802.3dj D1.0

Comment Resolution

Common Topics

Matt Brown (Alphawave Semi), 802.3dj Chief Editor
Leon Bruckman (Huawei)

Figure 176A-9—Coefficient update state diagram

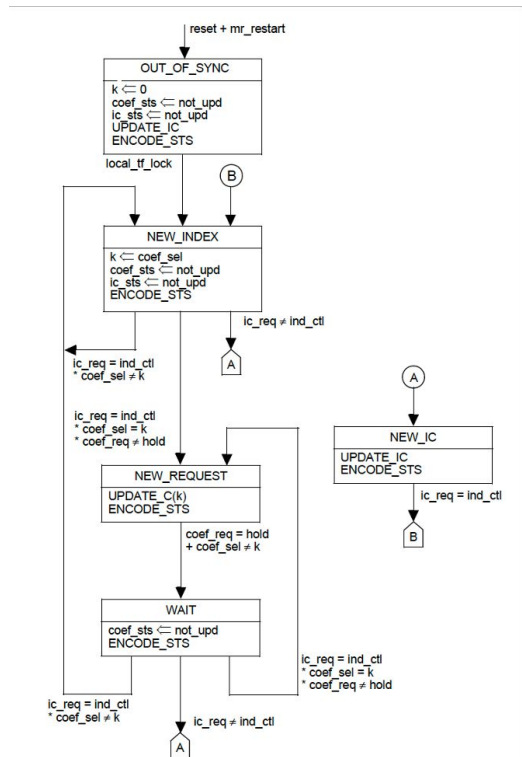
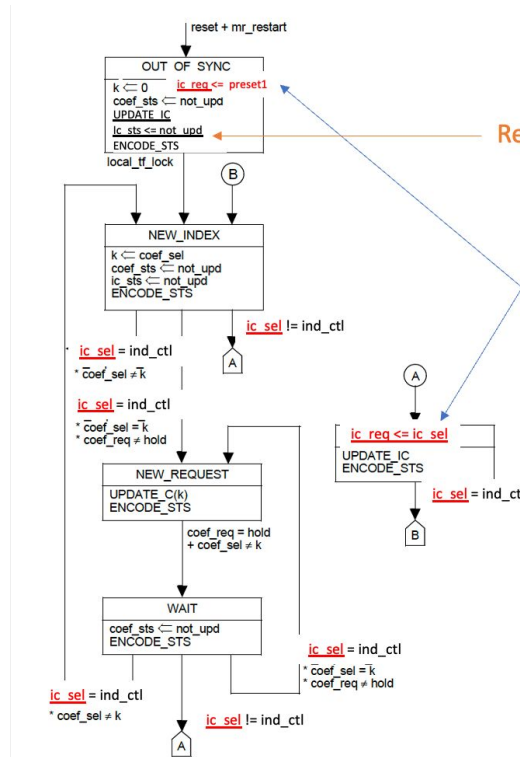
The UPDATE_IC function is called in the OUT_OF_SYNC state of the Figure 176A.9 Coefficient update state diagram. The UPDATE_IC function uses the ic_req variable to set the coefficients (see 176A.6.2), and the ic_req variable is derived from the 'initial condition request' bits from the control field of the received training frames (see 176A.10.3.1).

Since, however, the OUT_OF_SYNC state is entered during reset (reset or mr_restart set true), it would seem unlikely that training frames are being received. If that is the case, it isn't clear what the value of the ic_req variable is, and therefore what the coefficients should be set to.

176A.6.2 says that 'The transmitter equalizer is set to preset 1 upon entry to the QUIET state of the interface control state diagram.'. Since the QUIET state of the Interface control state diagram is also entered during reset, it seems the coefficients should be set to preset 1 when the Coefficient update state diagram is in the OUT_OF_SYNC state.

- [1] Delete the first sentence of the ic_req definition in 176A.10.3.1.
- [2] Add the text 'If the Coefficient update state diagram is in the OUT_OF_SYNC state ic_req is set to preset 1. Otherwise, it is derived from the "initial condition request" bit of the control field of received training frames on the correspondent lane of the interface.' to the end of the ic_req definition in 176A.10.3.1.

Rename and create a new `ic_req`

~~`ic_req`~~ `ic_sel`

Enumerated variable derived from the “initial condition request” bits from the control field of the received training frames (see 176A.3). This variable may be assigned one of the following values (abbreviations used by the state diagram are included in parentheses): individual control (`ind_ctl`), preset 1, preset 2, preset 3, preset 4, preset 5.

`ic_req`

Variable that stores the most recent version of `ic_sel`.

176A.2.3 Training pattern

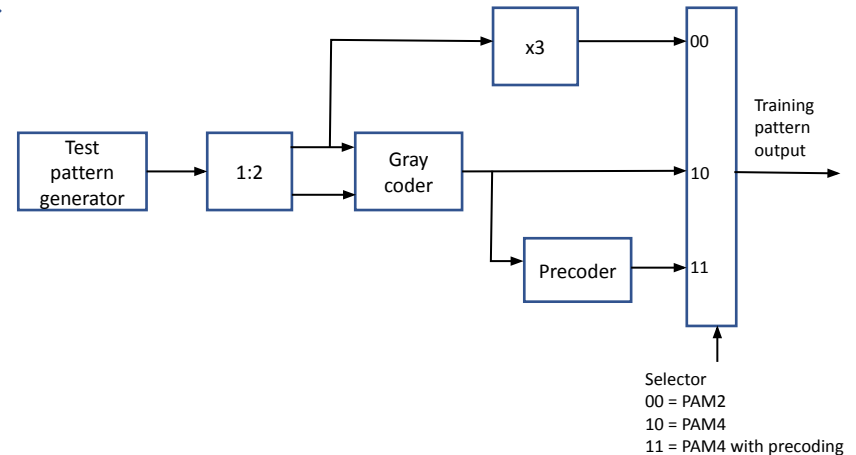
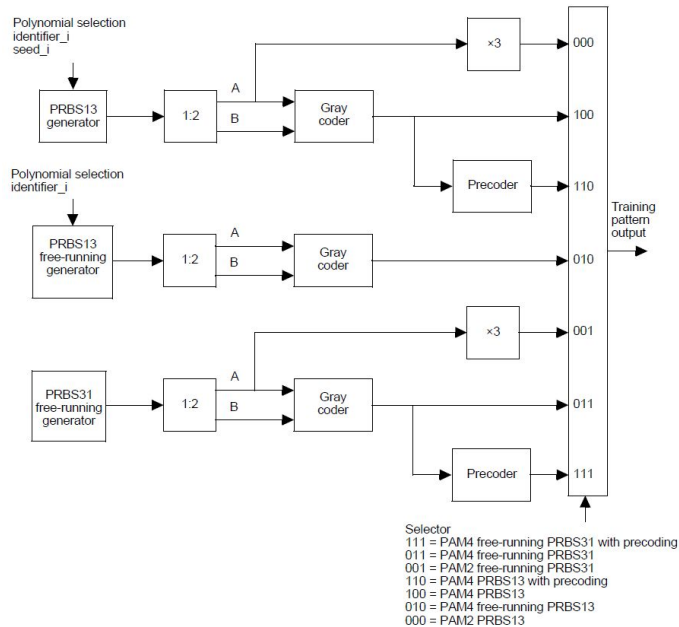
Training pattern options have been added to give receiver additional flexibility to successfully complete training. However, that flexibility is limited by a menu of fixed combinations of encoding and test pattern options. It would be better if encoding and test pattern selections were separated to allow receivers to request whatever combination best suits their needs. There is space in the control and status field structures to accommodate this.

In Table 176A-2, restore bits in control field bits 8 and 9 to the original "Modulation and precoding request" encoding defined in Clause 162. Define bits 5 and 6 to be "Test pattern request" with 00=PRBS13, 01=Free-running PRBS13, 10=Reserved, and 11=Free-running PRBS31. Restore bits 10 and 11 in the status field (Table 176A-3) to the "Modulation and precoding status" encoding defined in Clause 162. Define bits 12 and 13 to be "Test pattern status" using the same encodings as the control field. Update Figure 176A-2, 176A.3.2, and 176A.10.3.1 accordingly. Also add subclauses corresponding the Modulation and precoding request/status fields.

The training pattern is the result of a training pattern generator equivalent to the structure shown in Figure 176A–2.

There are three test pattern generator functions: PRBS13, PRBS13 free-running, and PRBS31 free-running.

The test pattern may be PAM2 or PAM4 modulated. For PAM4 modulation, precoding may be enabled or disabled.

The test pattern selector is set to PRBS13 and the modulation to PAM2 upon entry to the QUIET state of the interface control state diagram (see Figure 176A–6).

NOTE—Exiting TRAINING mode requires both sides to use PAM4 modulation, thus the modulation and precoding request and status are both required to have values other than PAM2.

Figure 136-3—Training frame structure

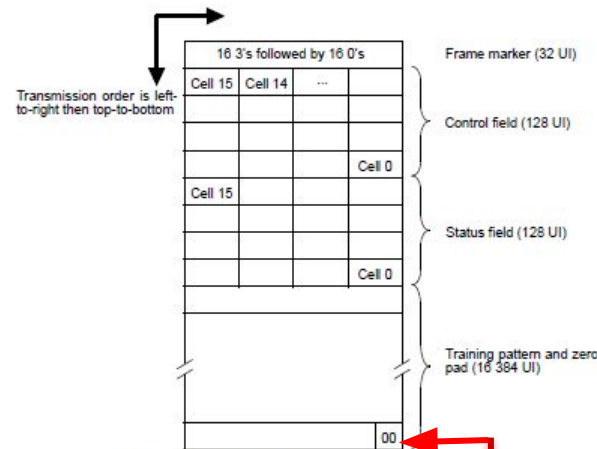
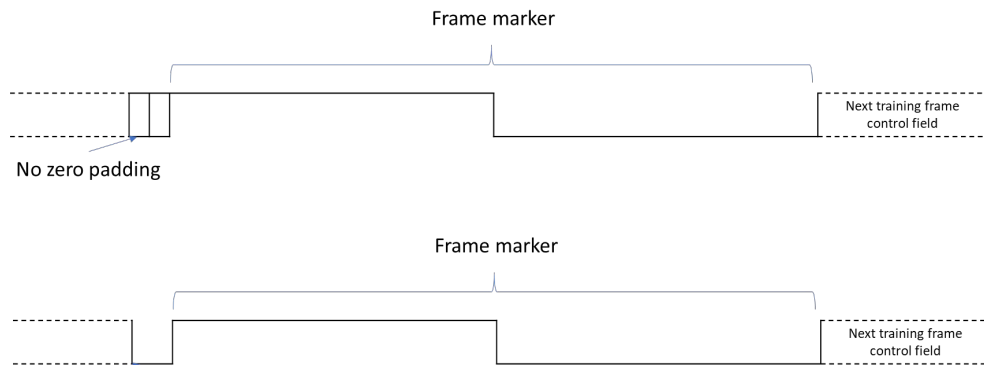
Bring the zero-pad back into the definition of the training frame. Stating that it is immediately precedes the training frame marker to provide a distinct transition from training pattern to frame marker of the next training frame.

These padd bits are not present in the training frame if the test pattern is free-running PRBS13 or PRBS31

Figure 176A-6—Interface control state diagram

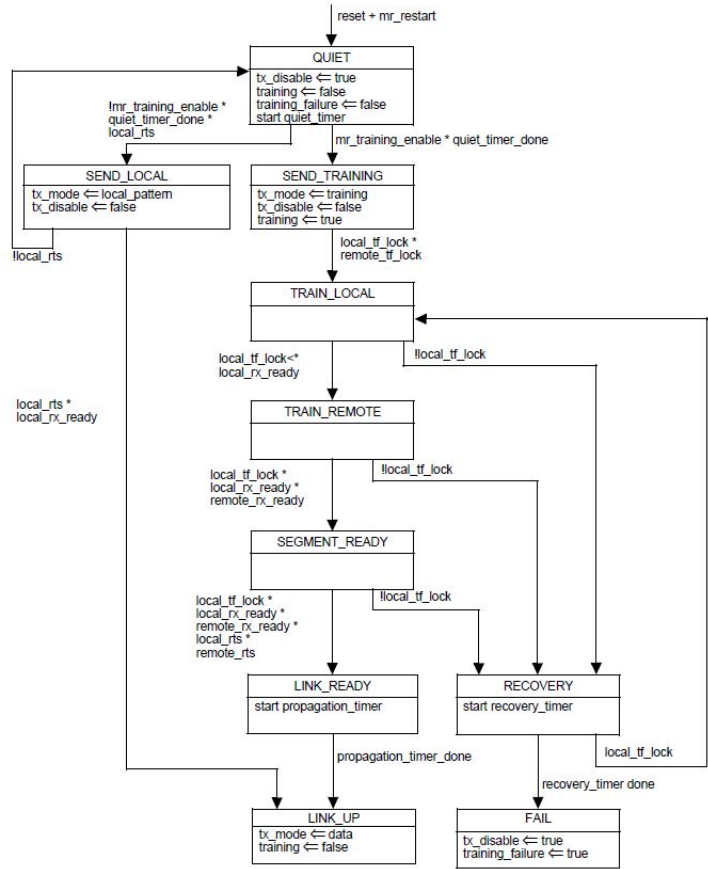
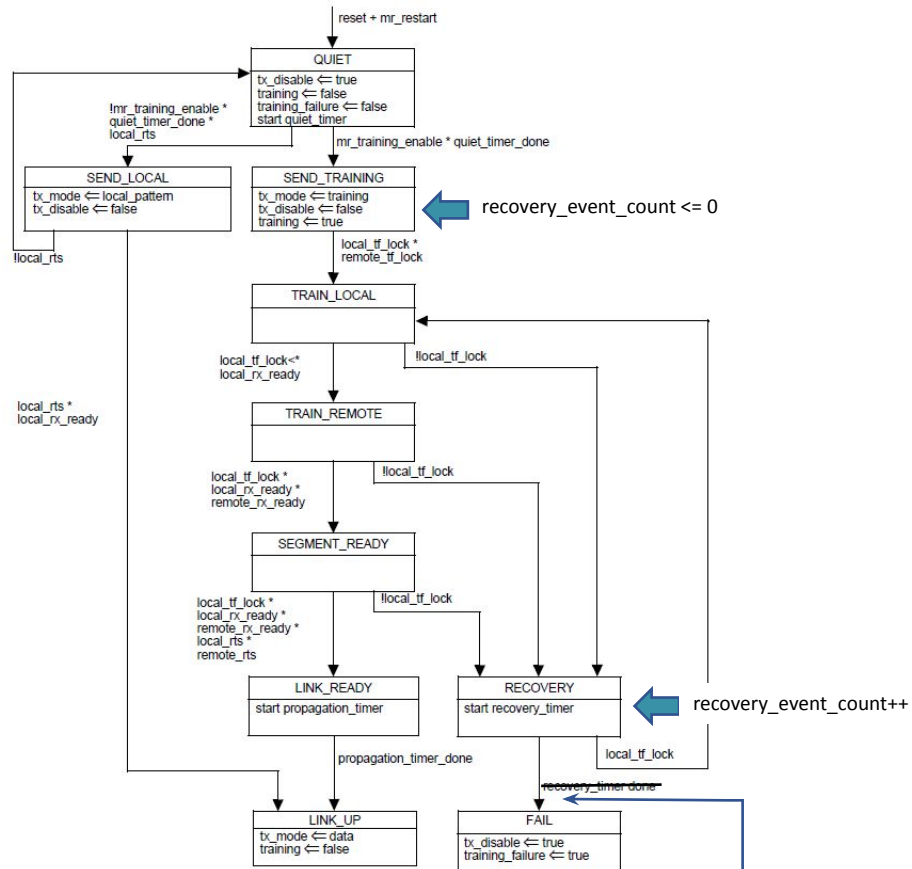
The comment refers to Figure 176A-6 Interface control state diagram. The RECOVERY state coupled with the absence of timeouts, introduces a new challenge in identifying marginal performance cases. These cases may lead to repeated transitions between TRAIN_LOCAL/TRAIN_REMOTE/SEGMENT_READY state to/from RECOVERY state in scenarios of alternating local_tf_lock. A possible solution is to limit the number of RECOVERY events by counting and limiting the number of transitions to the RECOVERY state.

The transition condition from the RECOVERY state to the FAIL state needs to be modified as follows:

Change `recovery_timer done` to `recovery_timer done || recovery_event_count > X`, where X is 5 (or to be determined).

The suggested change has merit, but the suggested threshold of 5 is somewhat arbitrary. Depending on implementation, other thresholds may be preferred, or this condition may be disabled, without affecting interoperability.

"max_recovery_events. Integer variable that controls the maximum allowed number of transitions into the RECOVERY state in the Interface control state diagram (Figure 176A-6). A value of zero allows unlimited number of transitions. The value of this variable is implementation dependent."

"recovery_event_count. This counter increments each time the control state diagram (see Figure 176A-6) transitions into the RECOVERY state."

Modify the transition condition from the RECOVERY state to the FAIL state as follows...

Change "recovery_timer done"
to "recovery_timer done + (max_recovery_events != 0)*(recovery_event_count >= max_recovery_events)".

recovery_timer done +
 (max_recovery_events != 0) * (recovery_event_count >= max_recovery_events)
